Section 2.2 page 27 last sentence:

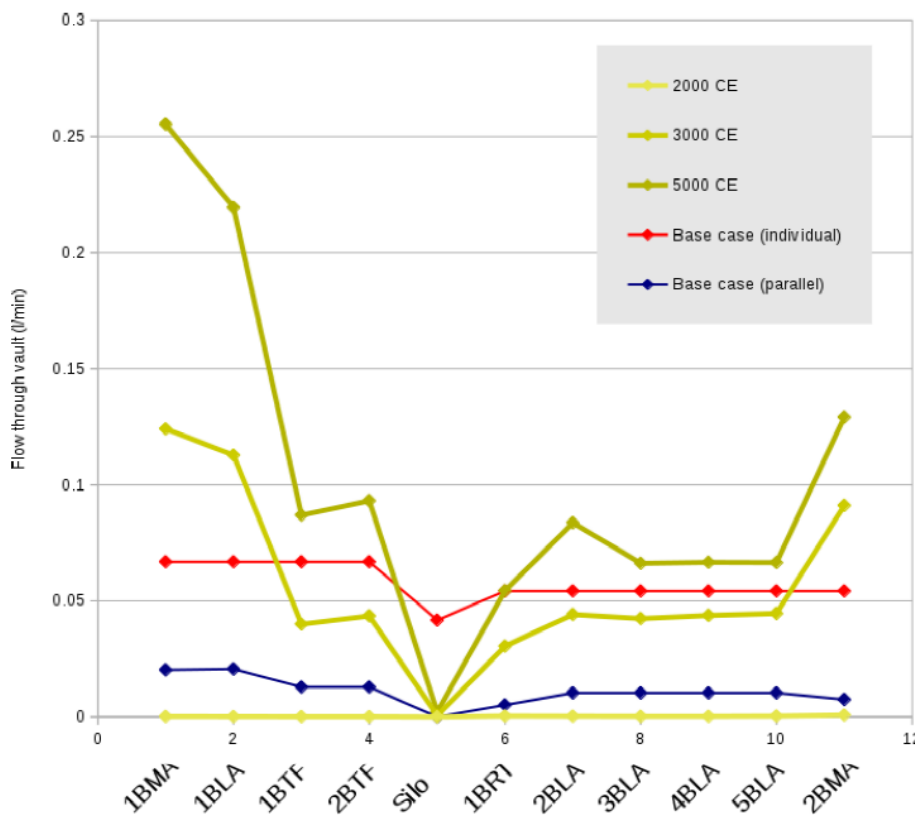
Figure 2.13 page 28 is to be replaced with:

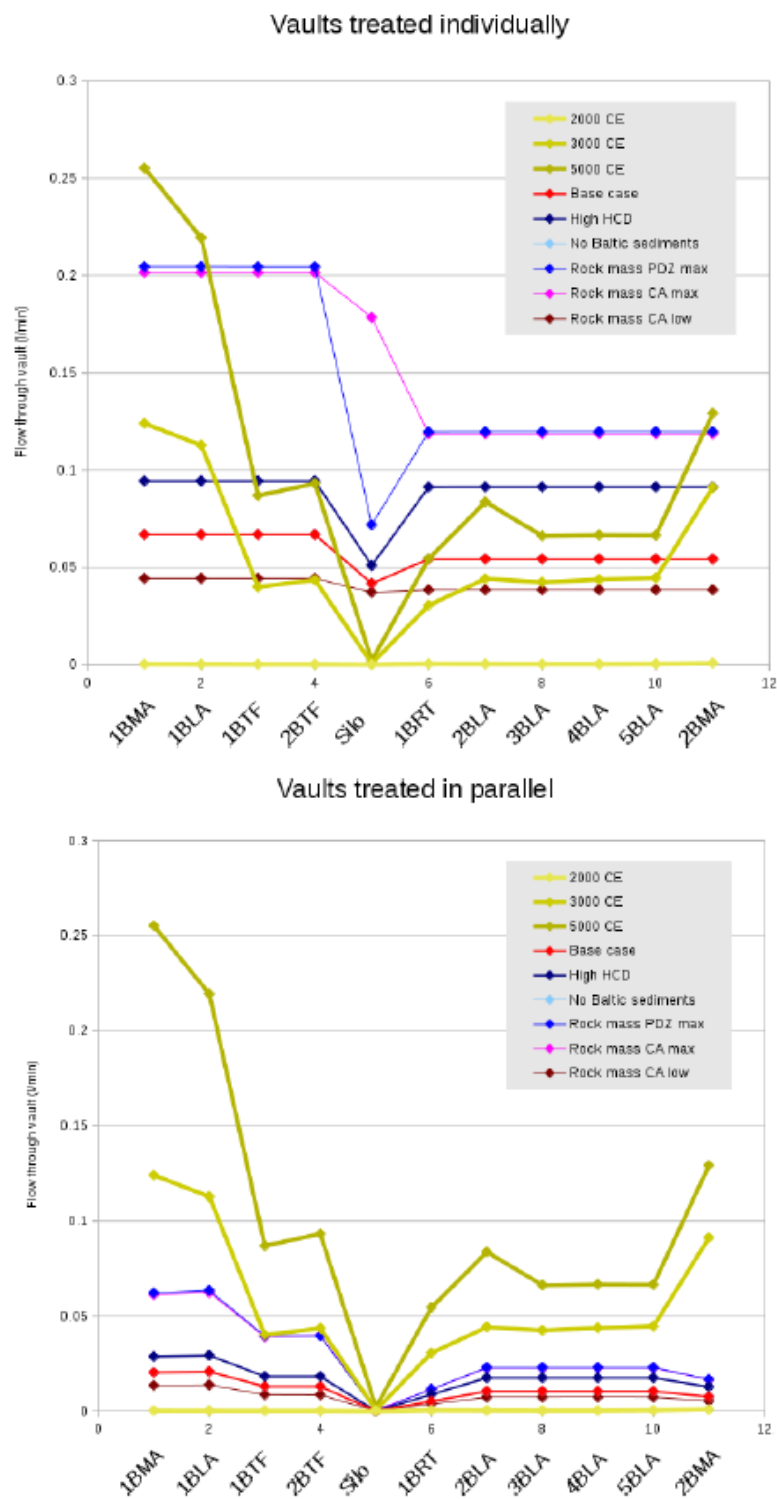
Figure 3.1 is to be replaced with:
